EVIA Position on Ecodesign requirements for ventilation units

10th April 2013

EVIA, the European Ventilation Industry Association, would like to thank you for the further draft working documents on Ecodesign requirements for ventilation units and the possibility to be involved in the current discussions.

Figure 1: Typical products and classification according EVIA proposal average climate

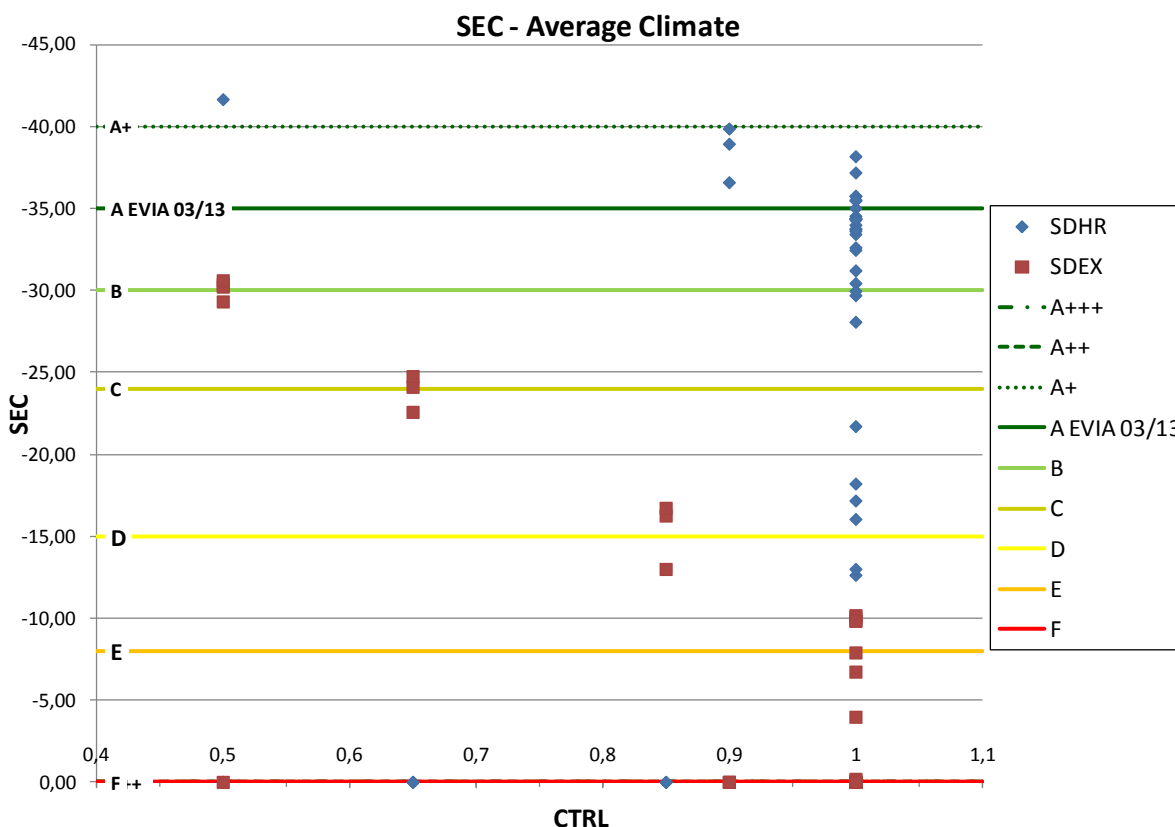
EVIA is proposing the following SEC classes, considering a common label for all types of residential ventilation units.

- A very good Exhaust Ventilation Unit (suitable for refurbishments) shall be able to reach a B classification in average climates with add controls options.
- A very good HR Ventilation Unit shall reach an A without any add. controls options. This reflects that a good heat recovery and an energy efficient fan have a reasonable position in applications. Tests of controls factors are not available (except passive air transfer devices).

Figure 2: Typical products and classification according EVIA proposal warm climate

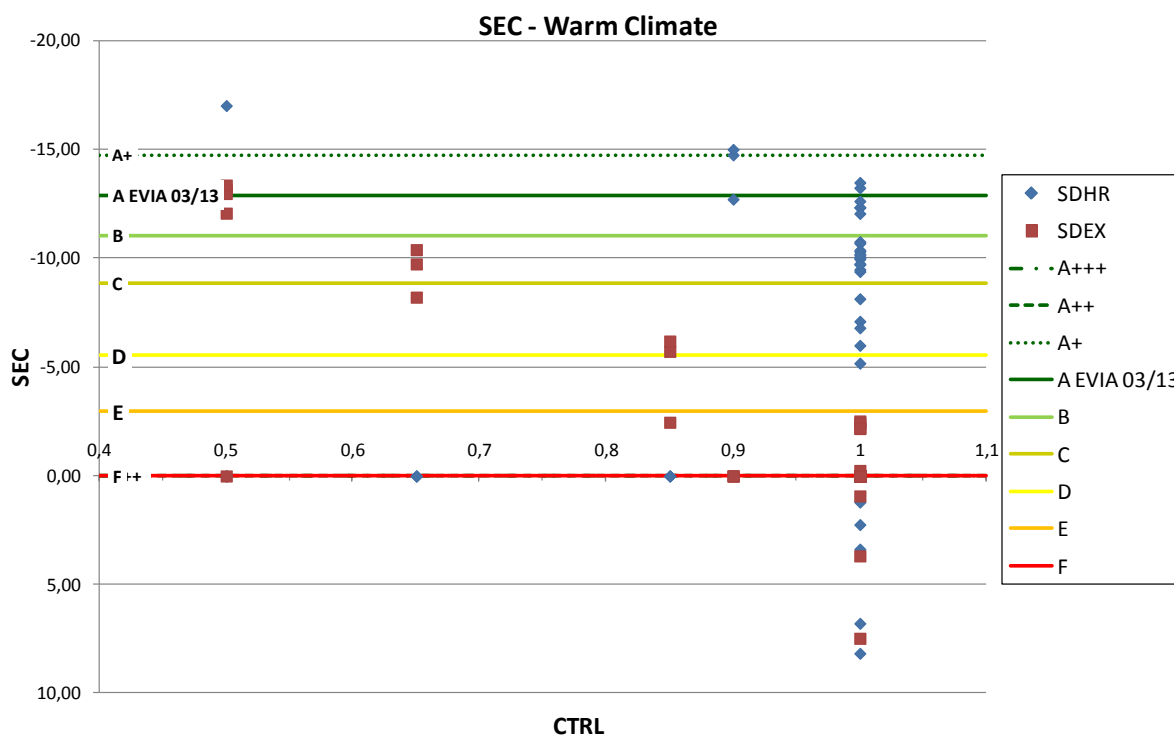
- In warm climate zones a very good demand controlled exhaust ventilation system is comparable to a good HR-unit (no controls option) and in class A (Figure 2).
- In cold climates the exhaust ventilation systems are lower (Figure 3).
- The proposal reflects also the size of the units. In refurbishments and multifamily dwellings, space for the ventilation unit is limited.

Figure 4: Proposal for a modified fan system efficiency

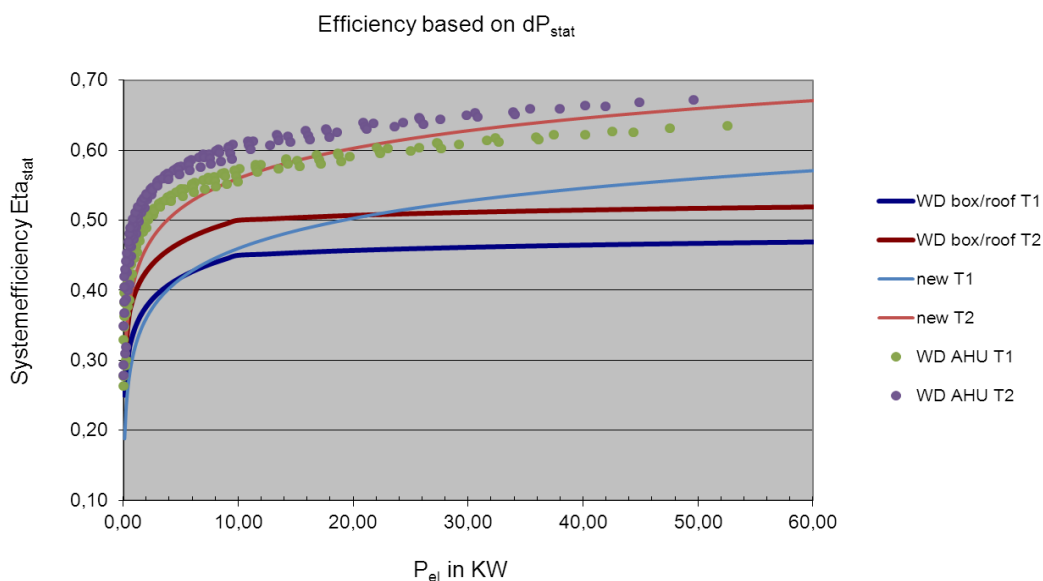
As a compromise and considering the current discussion on SFP values EVIA proposes a modified formula for the fan system efficiency.

- Solves the inconsistency with EN 13053 pm classes.
- Gives add. 2 years for the industry needed to redevelop a great variety of products and applications between Tier 1 and 2.
- Comparable efficiency in Tier 1 at higher power, but solves the problems of smaller fans in smaller units to reach the target.
- Higher efficiency in Tier 2

$$\eta_{\text{ref}} \geq 6,2 \times \text{LN}(\text{Pm}) - 14,3 + X$$

$$\text{T1: } X = 46$$

$$\text{T2: } X = 56$$

Figure 5: Typical box and roof fans and the EVIA proposal for min efficiency

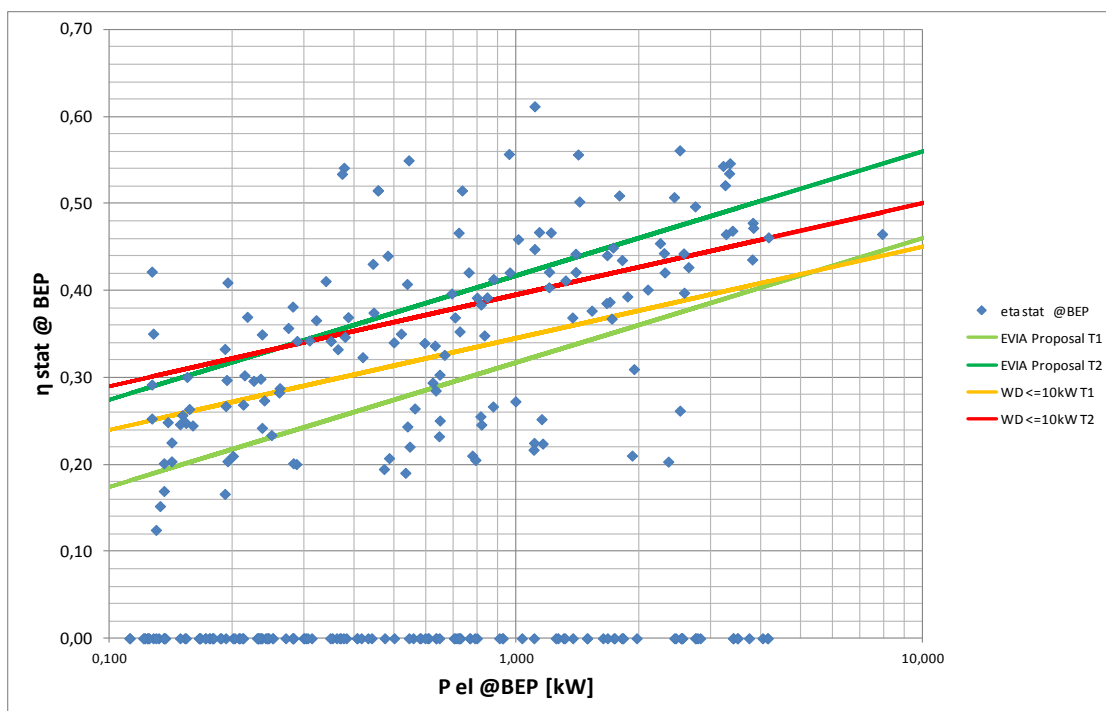
- The fans inside shall comply with the fan regulation EU 327/2011. No further intermediate requirements for fans > 125W needed.

Figure 6: Air Velocity as a function of unit size

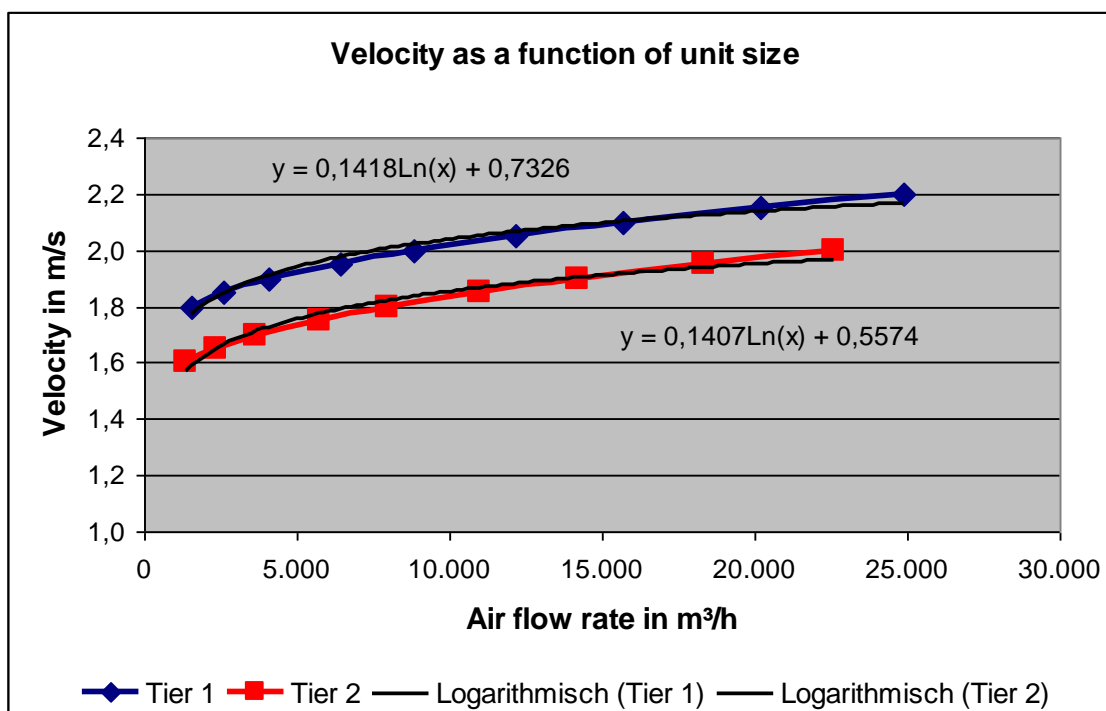
The velocity inside of the unit can be defined as a function related to the air flow rates in m³/h

Figure 7: Proposal for max SFP values for HR ventilation units.

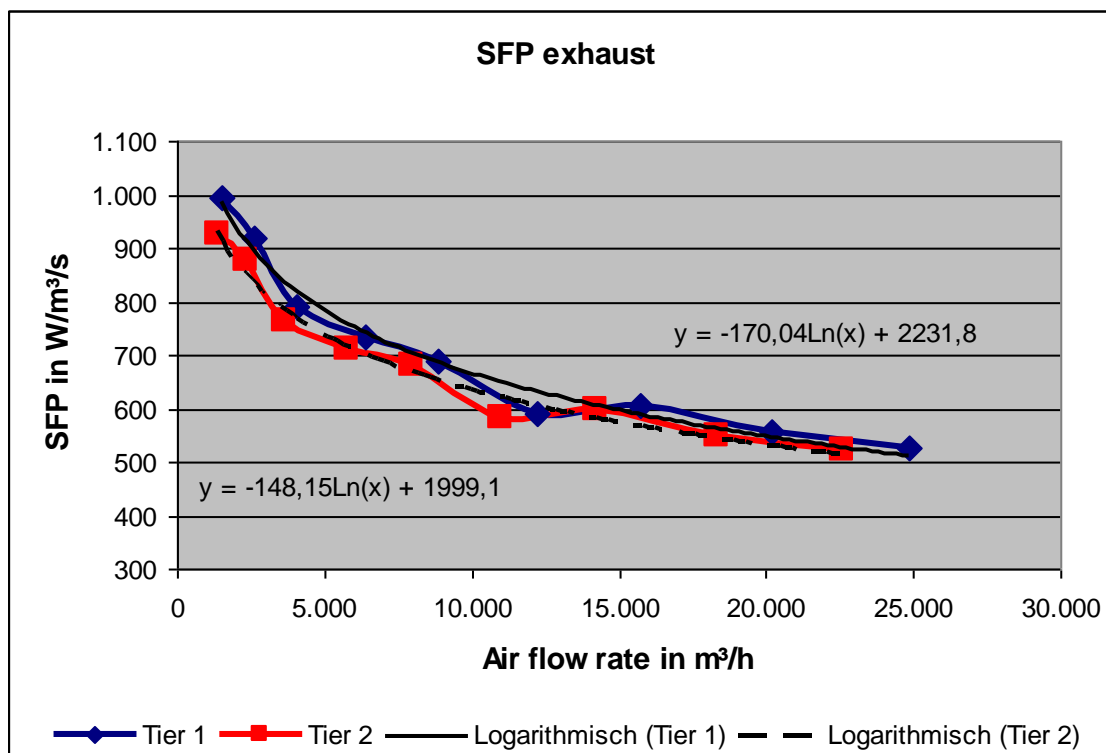
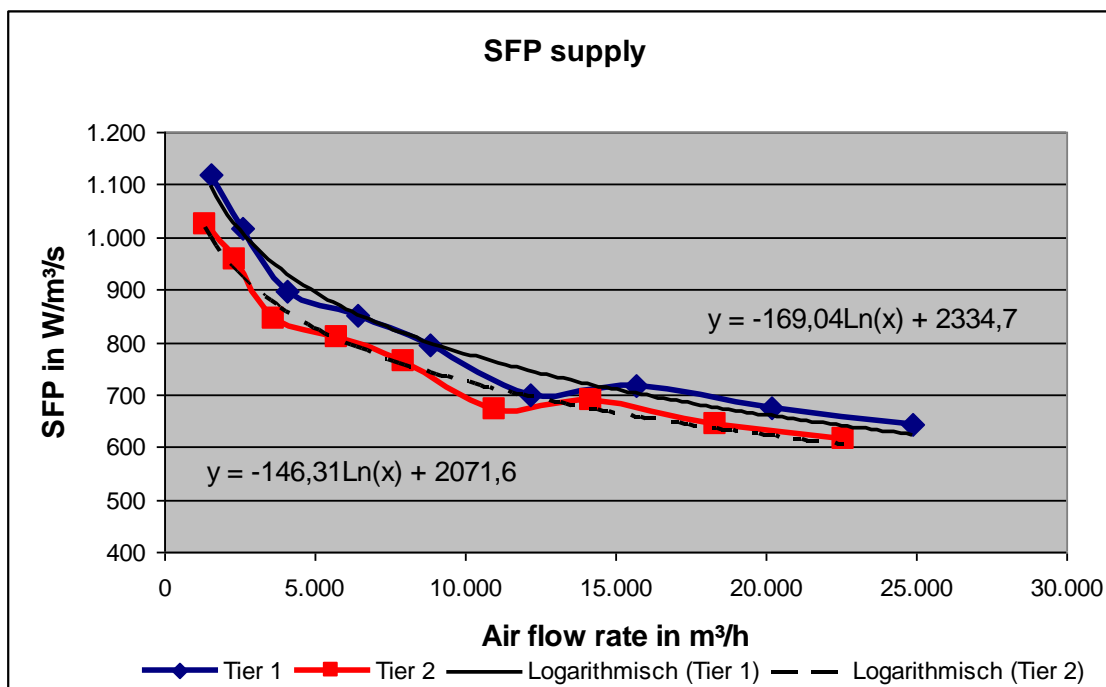
Therefore we need a separation in SFP related to the different systems and to the size of the units (air flow rate):
